APPENDIX B
COMMENTS ON THE INITIAL STUDY/NOTICE OF PREPARATION

Subject: Water Right Application No. 30166, El Sur Ranch, Monterey County - Notice of Preparation, Draft Environmental Impact Report (DEIR), SCH# 2006061011

Subject: Response to Notice of Preparation of Draft Environmental Impact Report for Water Right Application 30166 by El Sur Ranch to Appropriate Water from Big Sur River Subterranean Stream, Monterey County

Re: **El Sur Ranch Water Right Application #30166**
Response to Initial Study and Notice of Preparation

Figure 1

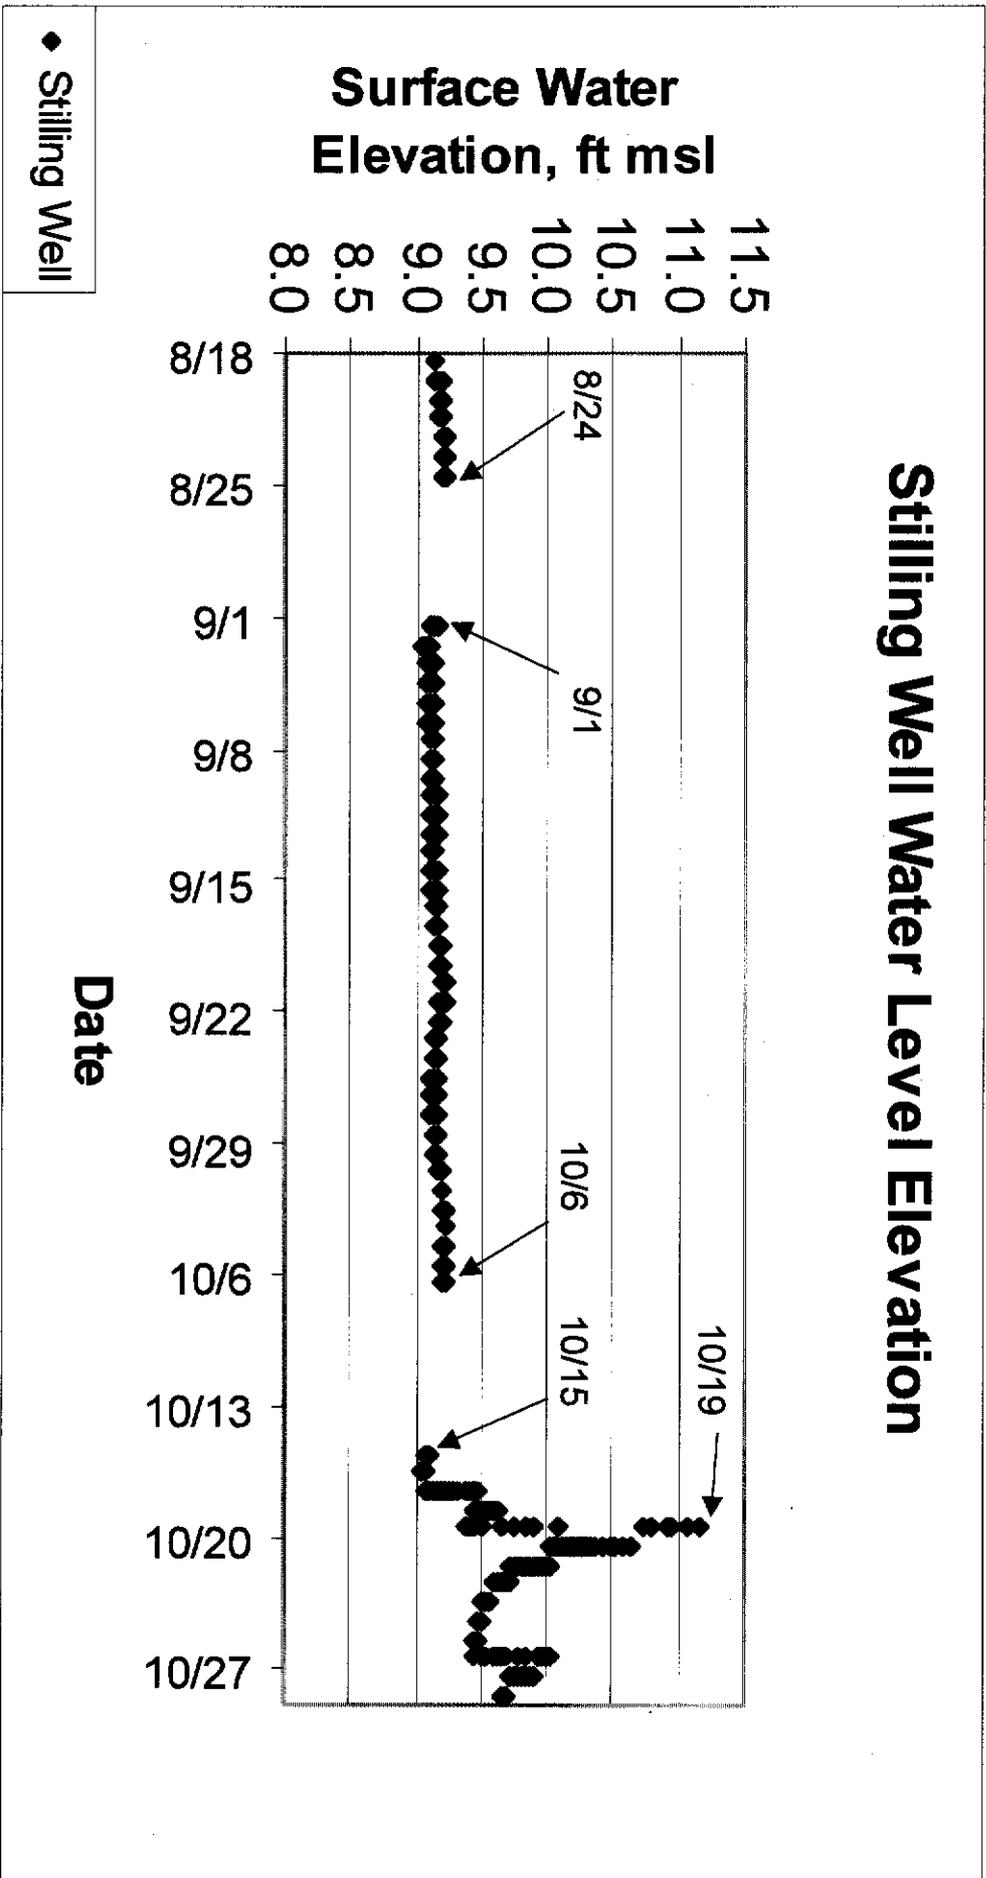
- b. The available information on the hydraulic gradient between the river and the aquifer comes from the river elevations measured at the stilling well installed near VT#2 (see SGI Figure 1-3), and water levels measured in the ESR-10 wells located in a southwesterly direction about 300 feet from the New Well (see SGI Figure 2-2). The direction of hydraulic gradient between the stilling well and ESR-10 wells was always away from river towards the pumping wells (see attached Figures 1 and 2). Similarly, the direction of hydraulic gradient between the stilling well and the more distant monitoring wells ESR-02 and ESR-03 located approximately 750 to 800 feet from the river was also always sloping from the river towards the pumping wells. This suggests that the losing reach of the Big Sur River extends at least into the area of the stilling well near VT#2. Additional information is needed to determine how far upstream and downstream the losing reach extends.

- b. As noted above, the SGI report acknowledges that the river between VT#1 and VT#2 is a losing reach. The change in water levels at the stilling well and the increase in groundwater gradient that resulted from the increased pumping rate document that river losses from pumping can extend downstream to at least VT#2. Before September 19th, the Old Well was pumping at 2.55 cfs (see SGI Table 2-2). After the New Well began pumping, the combined rate of pumping was approximately 4.8 cfs, an increase of approximately 88%. Because the flow of ground water follows Darcy's Law, a change in groundwater flow is proportional to the change

Figure 2

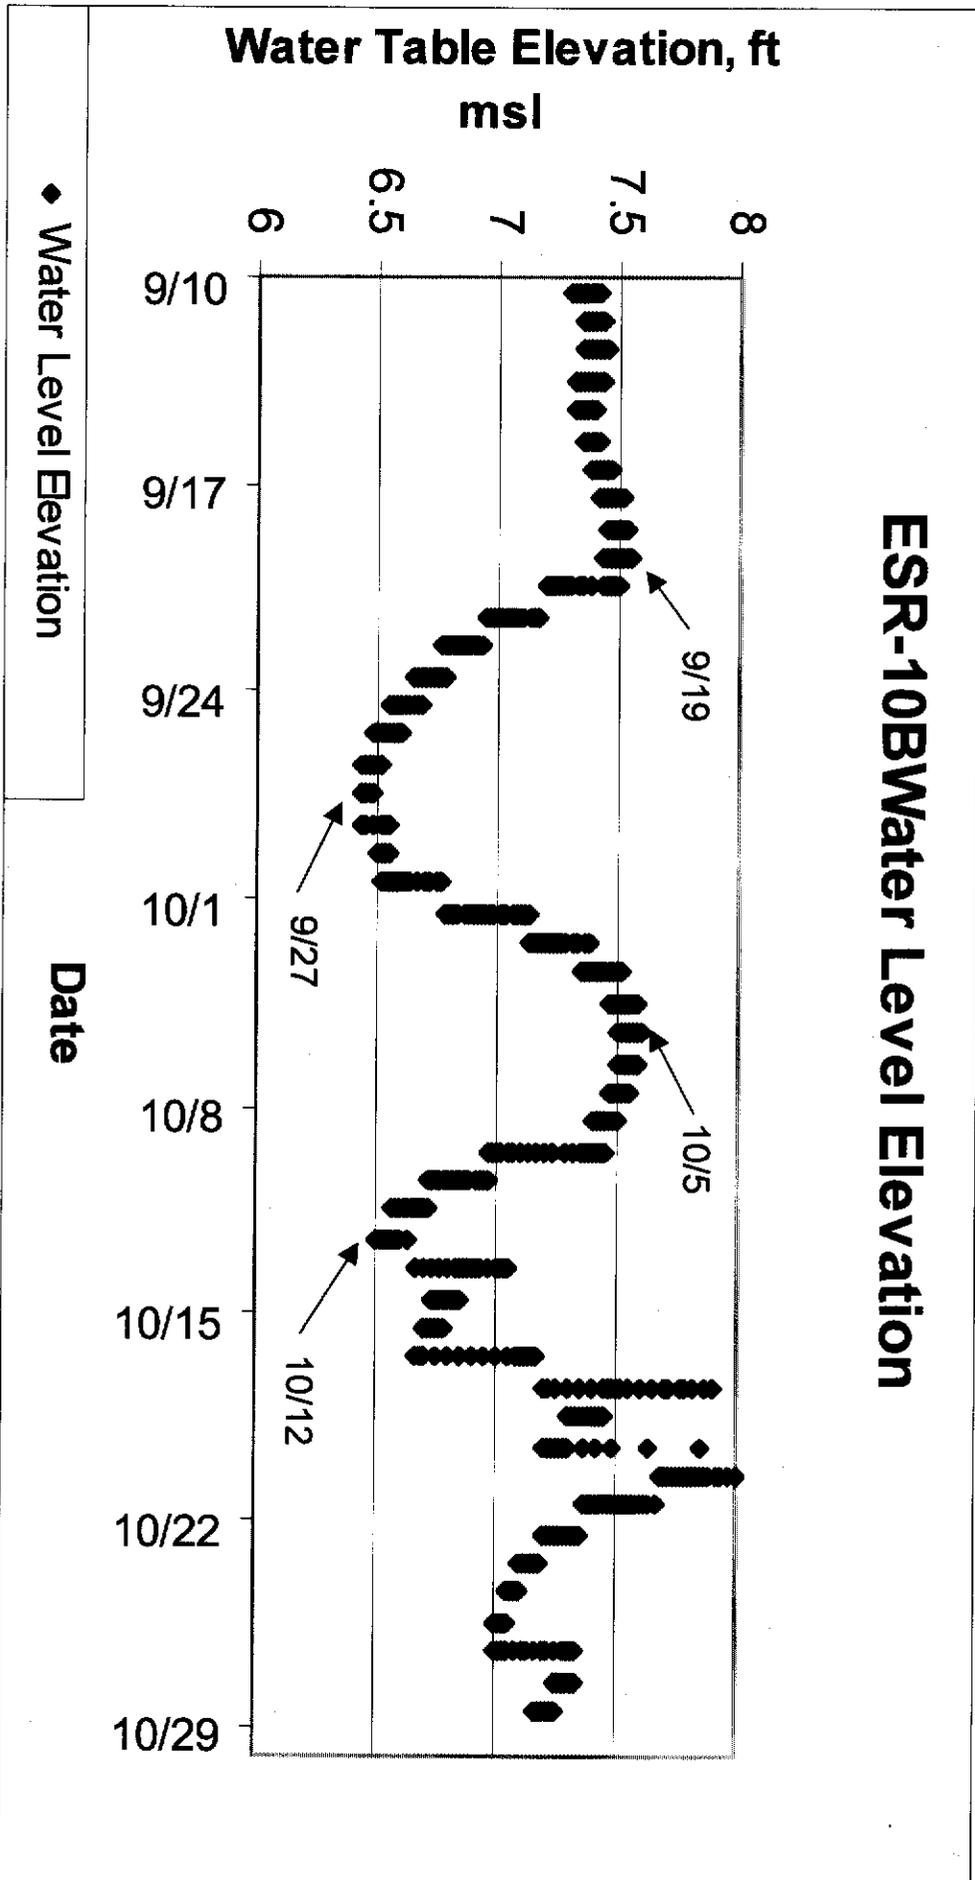
in hydraulic gradient. With an almost doubling of the pumping rate, the hydraulic gradient between VT#2 and ESR 10-B increased approximately 50 percent (SGI Figure 3-36). This increase in gradient agrees with the analysis by Miller and Durnford (2005) that when the rate of stream depletion approaches the rate of pumping, then approximately half of the seepage occurs within a reach of stream centered on the well, the length of which is twice the closest stream-to-well distance. For the study area, the river's closest point to the New Well is approximately 500 feet away (see SGI Figure 2-2) and VT#2 is approximately the same distance upstream. Therefore, with the 88% increase in pumping rate, the hydraulic gradient of ground water increased by approximately 50%, which suggests an increase in seepage losses from the river of approximately 50%.

Figure 5

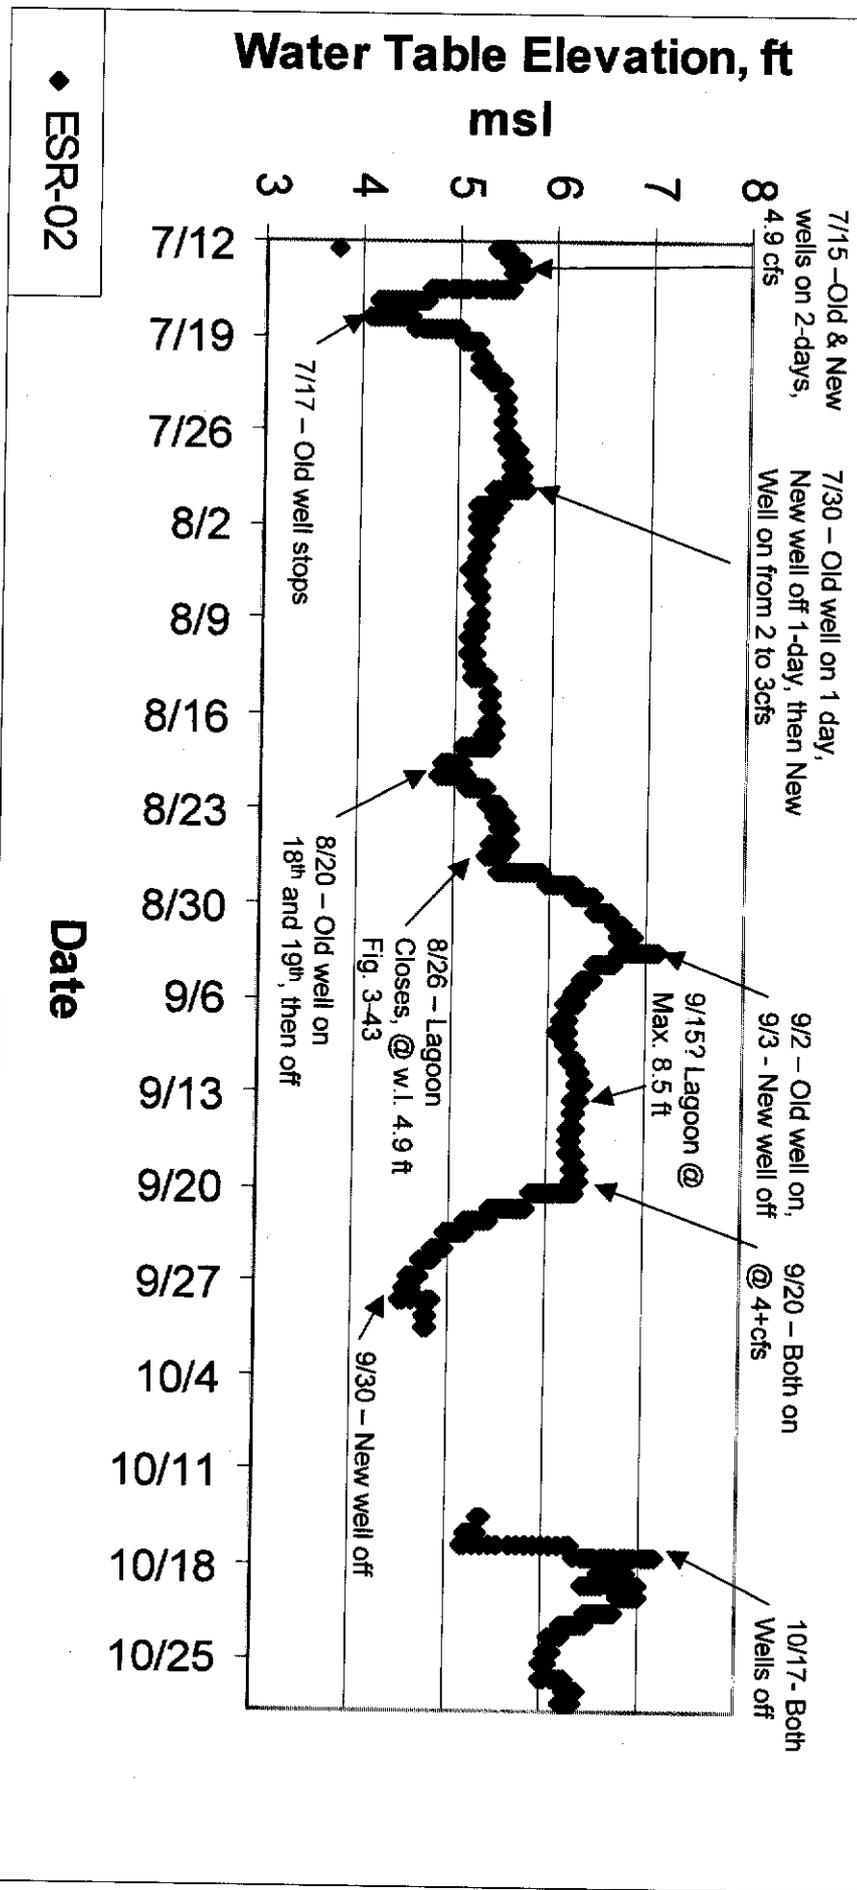
- d. On August 26, 2004, when a sand bar closes the river's outlet, the lagoon surface water level starts rising from approximately 5.2 feet above msl and reaches 8.5 feet above msl by mid-September (see SGI Figure 3-43 and section 3.4.8.3). By the end of September, the lagoon surface drops to approximately 6.75 feet above msl. Groundwater levels in monitoring wells also go up approximately 1.5 feet to 2.0 feet by the start of September (see SGI Figure 3-44 and section 3.4.8.3). By mid-September, groundwater levels drop back to below approximately 6.25 feet above msl. The attached Figure 5 shows the changes in groundwater levels at monitoring well ESR-02 which is representative of the effects of the

lagoon closure over a longer period than shown in SGI Figure 3-44. The rise in river stage with the closure of the lagoon may have extended upstream into the reach of the "cold pool" (see SGI Figures 3-28 and 3-29 for a comparison of lagoon water levels). The evidence for this can be found in the sampling depths of the water quality stations.
